DEPARTMENT OF THE AIR FORCE
AIR FORCE BASE CONVERSION AGENCY

SUBJECT: Submittal - Primary Document - Final Supplemental Investigations Report

Final Response to Comments Draft Report for Supplemental Investigations of Areas of Concern Griffiss Air Force Base Submitted November 1997

Comments on Draft SI Report sections by Dean Williams, U.S. Army Corps of Engineers, Kansas City District, Dated November 1997.

Figure 1-2A (NORTH)
 GRIFFISS AFB
 AOC LOCATION MAP

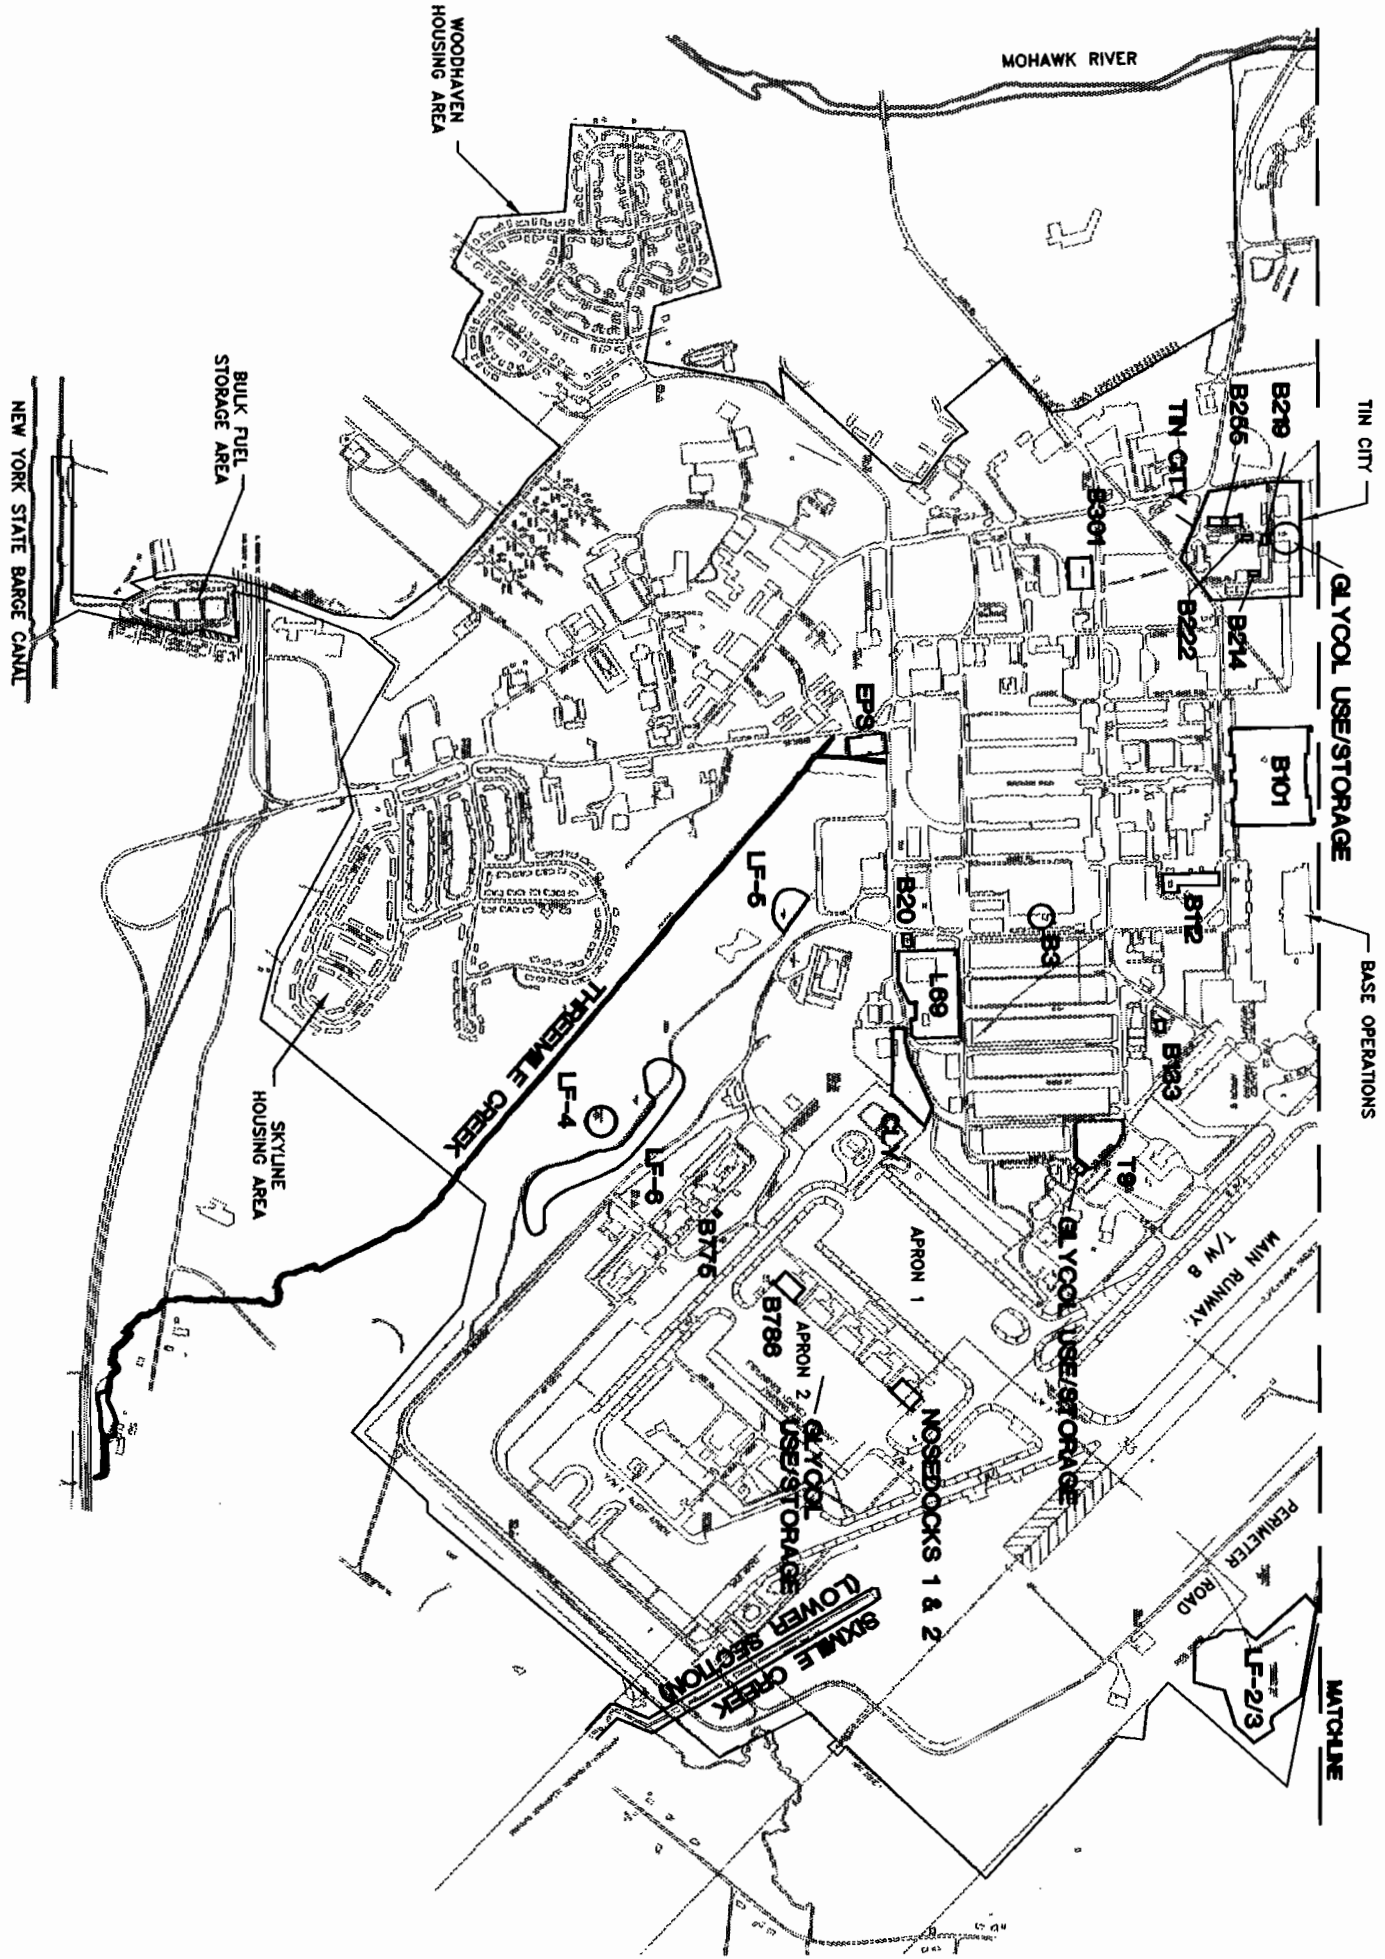
Figures 1-2A and 1-2B. Please mark and label at least a few major reference points on each figure.

Figure 4.5-3
SUPPLEMENTAL INVESTIGATION
SELECTED SOIL AND LEACHATE
SAMPLE RESULT MAP
LANDFILL 5

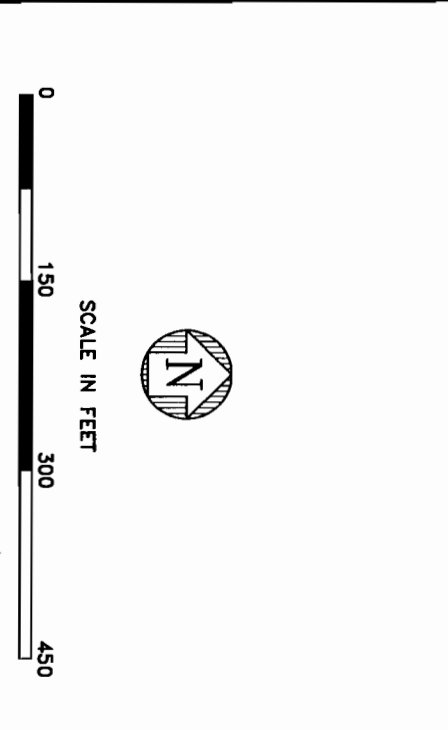
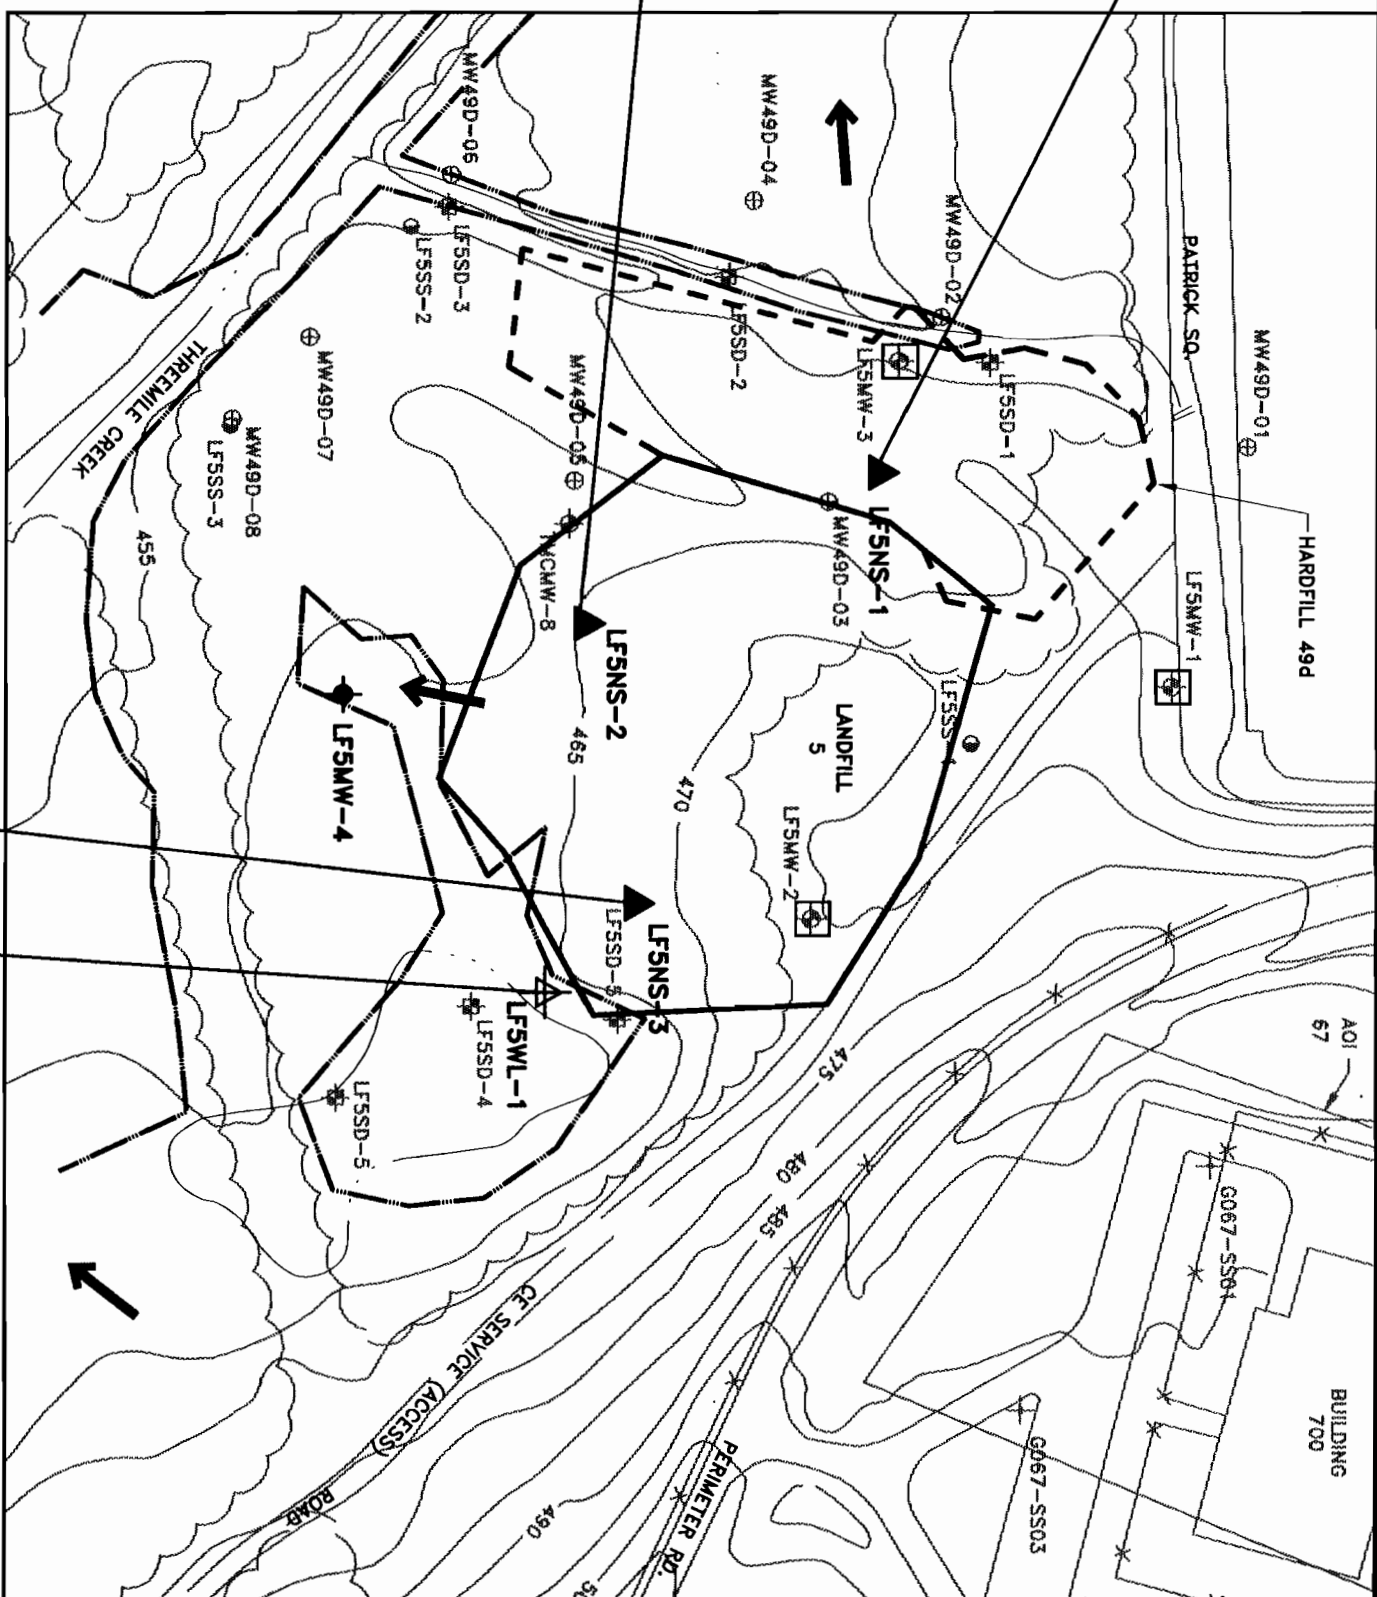
Figure 4.5-3. The section 4.5-2 on Remedial Investigation states that “the surface soil samples contained PAHs, dieldrin, and several heavy metals at concentrations exceeding the potential TBCs, and the PCB-1254 concentrations exceeding the NYSDEC cleanup goals,” please explain why the tables on Figure 4.5-3 indicate NA in the RI column?

The tables on Figure 4.5-3 (and also Figures 4.7-3, 4.8-2, 4.9-3 and 4.9-4) represent sample results from SI samples. Since RI samples were collected at different locations, RI data is not applicable (NA), for comparison purposes, with the SI samples. In order to alleviate confusion, the RI sample result columns were removed from Figures 4.5-3, 4.7-3, 4.8-2, 4.9-3, and 4.9-4.

Figure 4.6-1
SUPPLEMENTAL INVESTIGATION
SAMPLE LOCATION MAP
LANDFILL 6

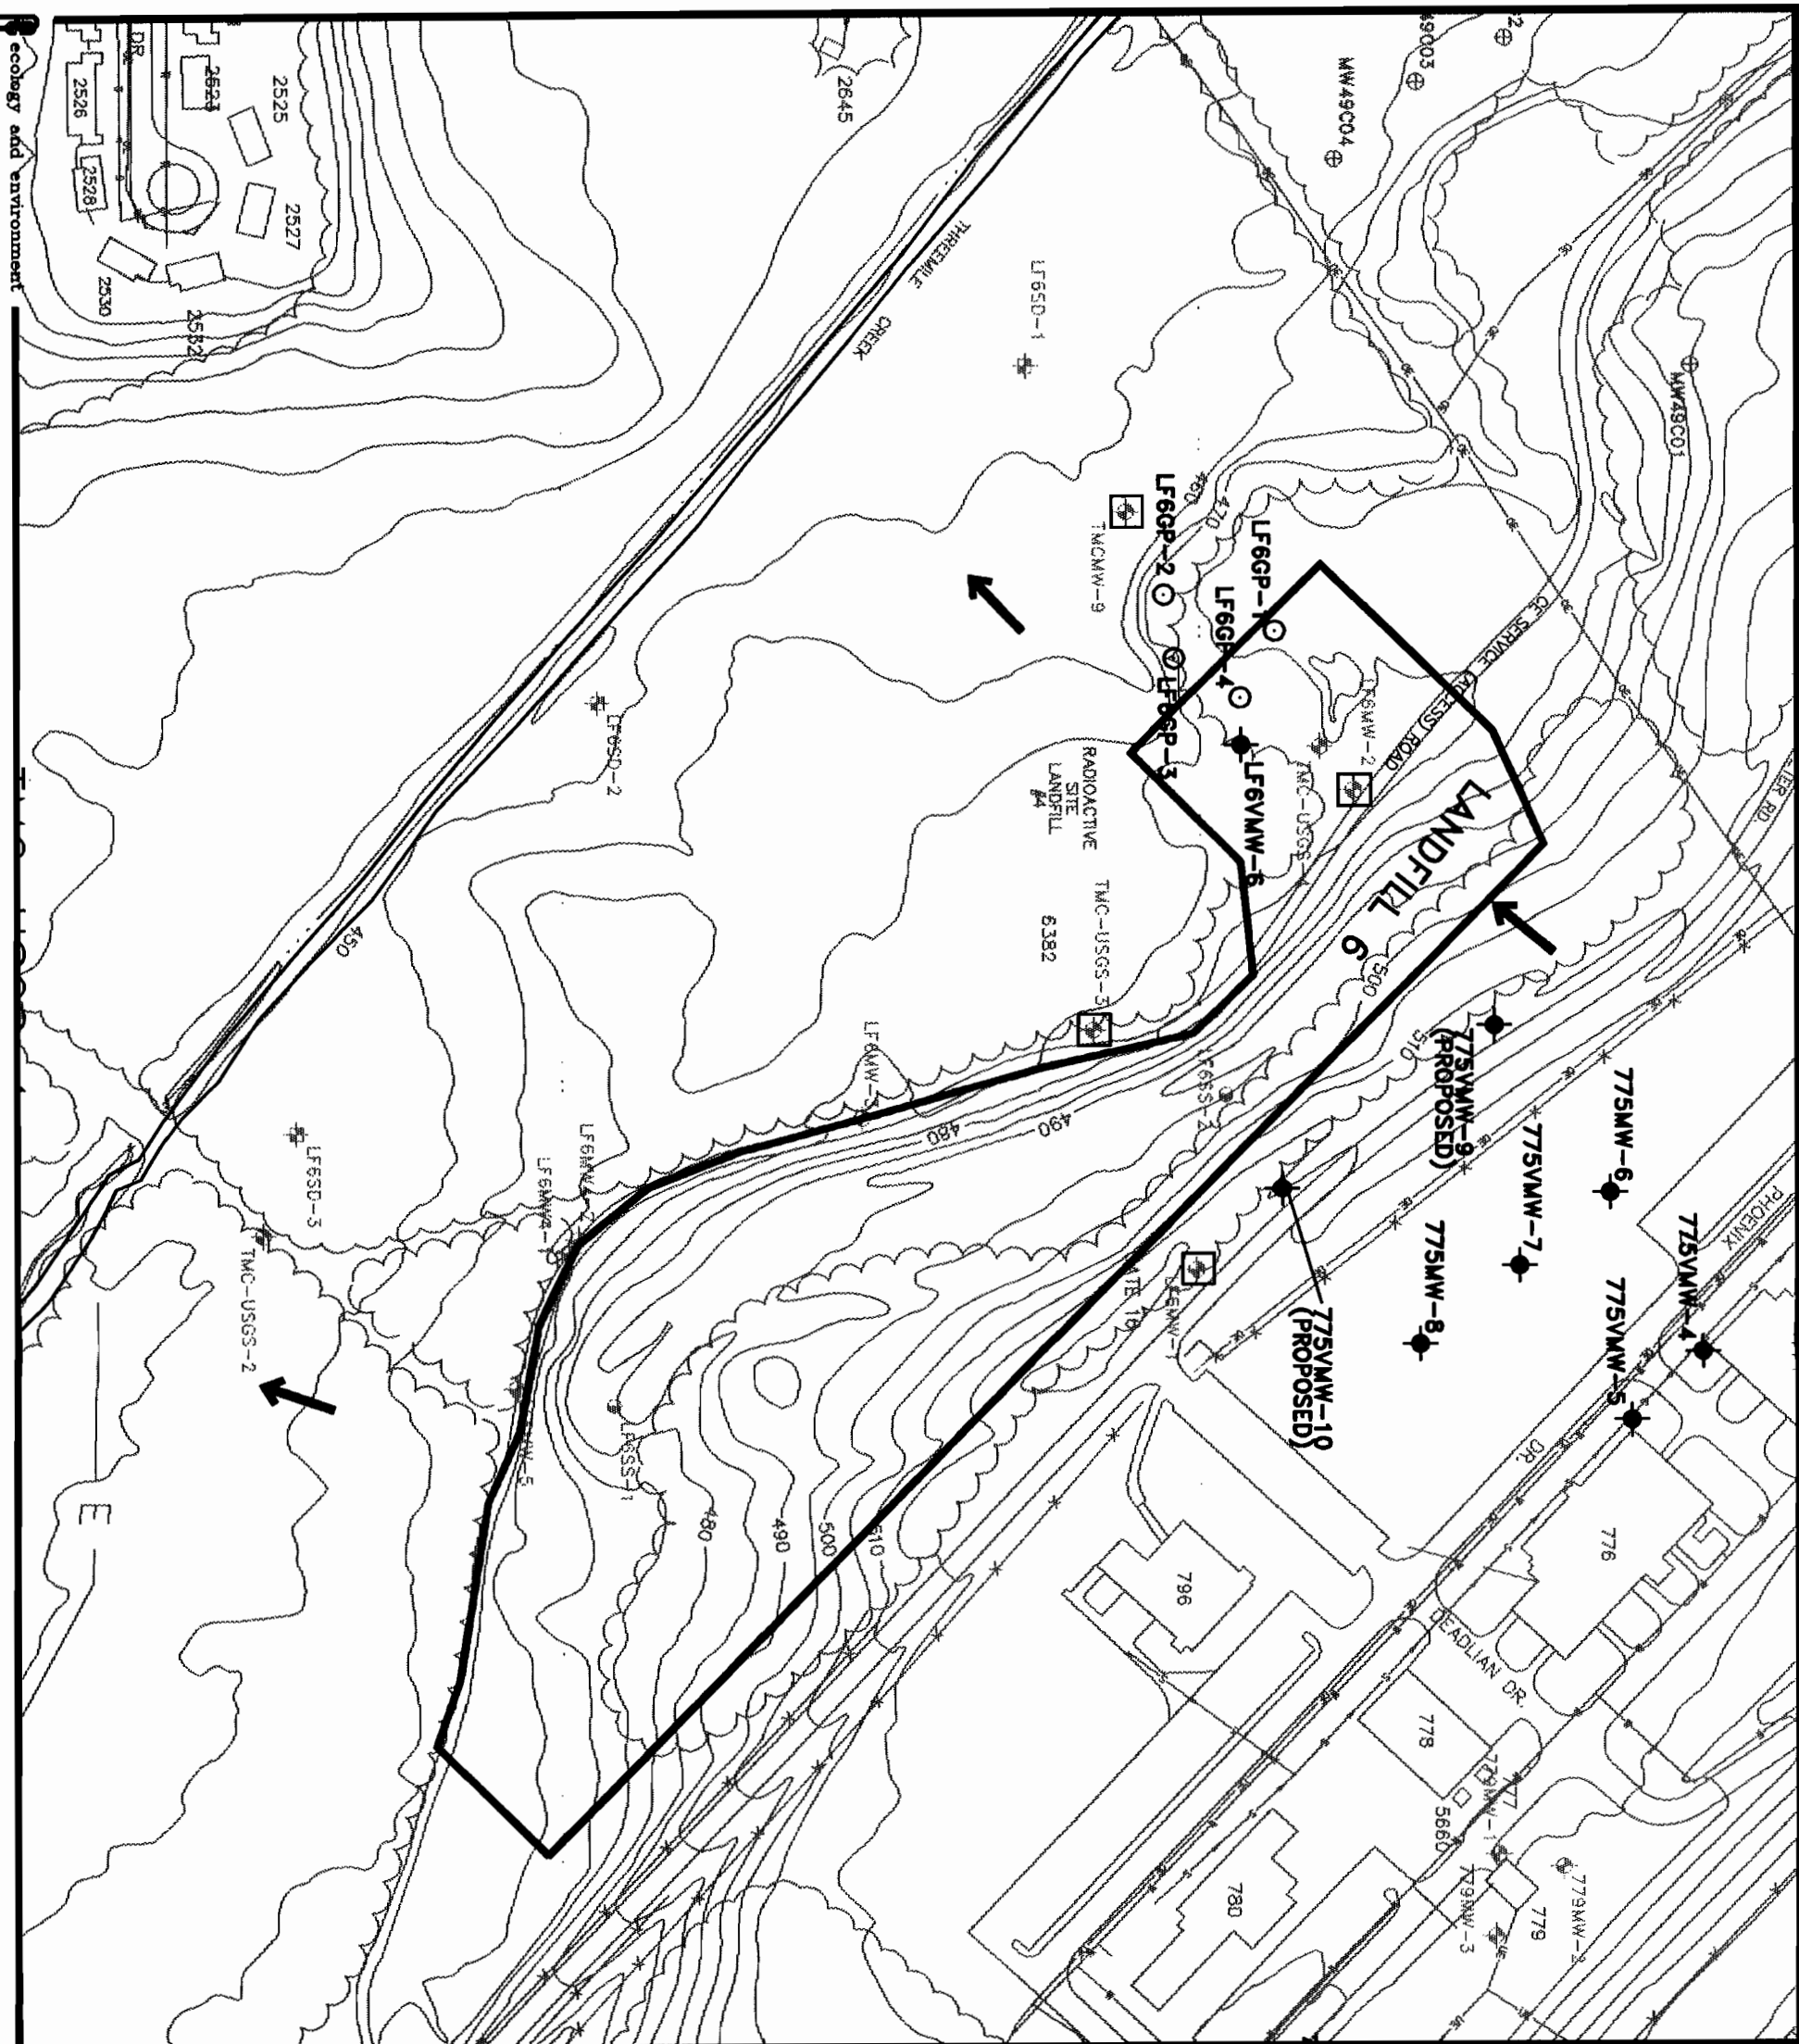
Figure 4.6-1. The Landfill 6 boundary shown on this figure differs from the boundary presented in the RI. Additional information should be provided to support this change in boundary lines, or the figure should be revised to be consistent with the RI.
